Informal document **GRE-87-30**
(87th GRE, 25-28 October 2022
agenda item 6 (a))

Revision of ECE/TRANS/WP.29/GRE/2022/21

A. Proposal for a new Supplement to the 06, 07 and 08 series of amendments to UN Regulation No. 48

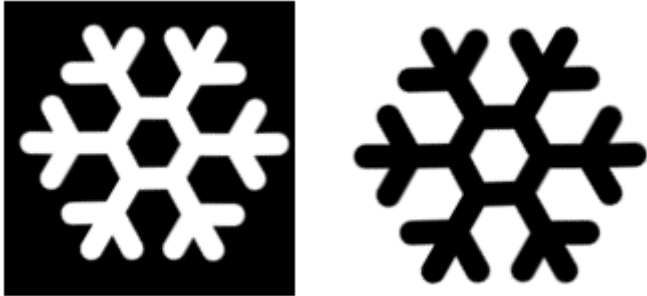
Symbols and Pattern	Use case	Conditions and remarks
	Slippery road warning	<p>Shall not be activated when the vehicle speed is less than 50km/h.</p>

<p>Risk of collision warning</p>	<p>Triggered when the relative speed is larger than 30 km/h and Risk of Collision Time is less than 1.4 s.</p> <p>Flashing at 4.0 hz +/- 1.0 hz allowed.</p> <p>Shall not be activated when the vehicle speed is less than 50km/h.</p>
	<p>Wrong way warning</p>	<p>Activated when the vehicle is entering a one-way road or a highway in opposite direction.</p> <p>Flashing at 4.0 hz +/- 1.0 hz allowed.</p>
	<p>Lane keeping assist warning</p>	<p>Activated if the vehicle unintentionally exits its lane.</p> <p>Shall not be activated when the vehicle speed is less than 50km/h.</p>

7. In Annex 16 (Symbols and patterns for the use as Driver Assistance Projections and Explanations of the Warnings/Highlights), a threshold in the speed value is added in ‘Conditions and remarks’ column for three symbols: ‘Slippery road warning’, ‘Risk of collision warning’ and ‘Lane keeping assist warning’. However, ‘Wrong way warning’ symbol is not covered by this requirement, as it is considered important for safety, also in urban areas.
